RAI Volume 3, Chapter 2.2.1.2.1, Sixth Set, Number 3:

Provide details of the parametric study that concluded appropriate variations in unconfined compressive strength for the five lithophysal rock categories would not affect significantly the results of the UDEC-Voronoi model. Describe how, for each rock-mass category, appropriate variations in unconfined compressive strength (e.g., SAR Figure 2.3.4-30) were used to calibrate and run the UDEC-Voronoi model.

Figure 1 Relation between UCS and Young’s Modulus for Lithophysal Rock Mass

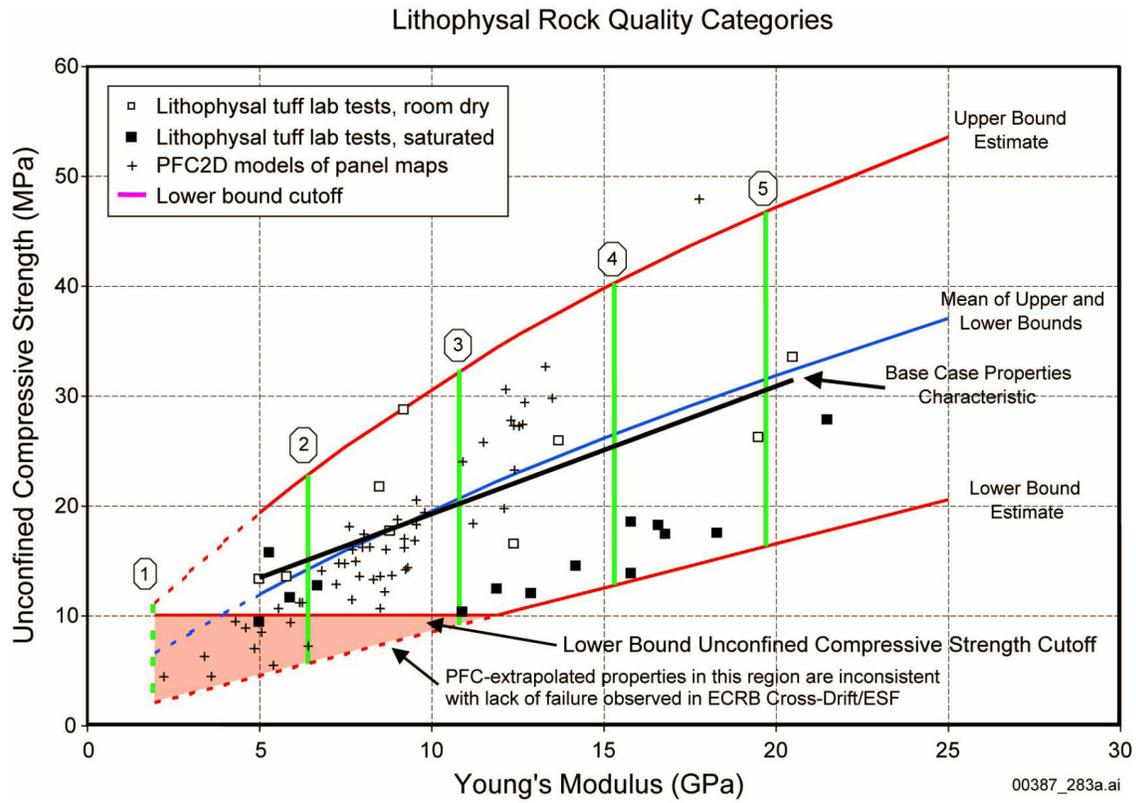
Basis: Spatial variability in rock properties can potentially affect models for drift collapse. DOE addressed this uncertainty by developing calibrated models for five different rock-strength categories, which are distinguished by different values of rock mass modulus. In conducting its calibration, DOE used the mean value of unconfined compressive strength as the calibration target for each selected value of rock mass modulus. DOE data show a large range of potential values of unconfined compressive strength for a given value of rock mass modulus (SAR, Figure 2.3.4-30). DOE stated (SAR, page 2.3.4-73) that a parametric study was conducted in which the Young's modulus and strength parameters were varied to account for the reasonable bounding ranges of lithophysal and nonlithophysal rock. DOE did not present results of analyses that showed appropriate ranges for rock strength were considered for the five lower lithophysal rock categories.

The lithophysal rock mass has been categorized into five rock mass quality categories that span the range of strength and stiffness variations observed during mechanical testing of large-diameter cores taken from the lithophysal rock mass. The test results, base-case properties, and upper and lower bounds for the relationship between unconfined compressive strength (UCS) and Young's modulus are shown in Figure 1, which is identical to SAR Figure 2.3.4-30.

The intersections of the vertical (green) lines with the black line in Figure 1 represent the base-case values of Young’s modulus and UCS used in the UDEC stability analyses of the emplacement drifts. Table 1 lists the base-case values of UCS and Young’s modulus for the five lithophysal rock strength categories. Table 1 also provides the porosity ranges for each rock category.

Figure 1 shows the scatter in the test results for UCS around the base-case line. Given this scatter, an estimated lower bound for UCS is defined by a solid red line in Figure 1, with numerical values provided in Table 1. Given the differences in base-case and lower-bound values for UCS in Table 1, a parametric study was performed to evaluate the potential impact of the variability in UCS on drift degradation in lithophysal rock units.

The parametric study is based on the lower-bound values for UCS in Table 1, with the additional constraint that the UCS should have a value of 10 MPa or greater. A minimum of 10 MPa is appropriate for UCS because lower values of UCS are inconsistent with the observed behavior in the Exploratory Studies Facility (ESF) and in the Enhanced Characterization of the Repository Block (ECRB) Cross-Drift. As discussed in *Drift Degradation Analysis* (BSC 2004, Sections E4.1.4.1 and E4.1.4.2), sections of the ESF and ECRB Cross-Drift would have shown significant damage and even rockfall from the drift walls under *in situ* conditions if the strength of the surrounding lithophysal rock mass were less than 10 MPa. However, the unsupported drift walls in the ESF and ECRB have remained in good condition, with no evidence of significant damage or rockfall. Based on these observations, the minimum value of UCS is defined as 10 MPa, and the lower-bound strength for rock mass categories 1, 2, and 3 is reset to 10 MPa. The lower bound for UCS, shown as a solid red line in Figure 1, includes the reset to 10 MPa.

Even with a cutoff or minimum of 10 MPa, the lower bound for UCS is conservative during the thermal period. The lower bound curve in Figure 1 is defined by test results for saturated cores, which are shown as solid black squares in the figure. The rock will dry out during the thermal pulse, so the UCS will be more similar to the test results for dry core, shown by the hollow black squares in Figure 1. As the test results for dry core are significantly greater than the test results for saturated core, the use of the lower bound for UCS does not accurately represent the strength of the lithophysal rock mass during the thermal pulse, particularly while the temperatures are greater than 100°C and thermally induced stresses are largest, because the rock will be dry. Regardless of this conservatism during the thermal dryout period, the parametric study is based on the lower-bound values for UCS (solid red line in Figure 1) to represent the greatest impact of the variability in UCS on drift degradation.
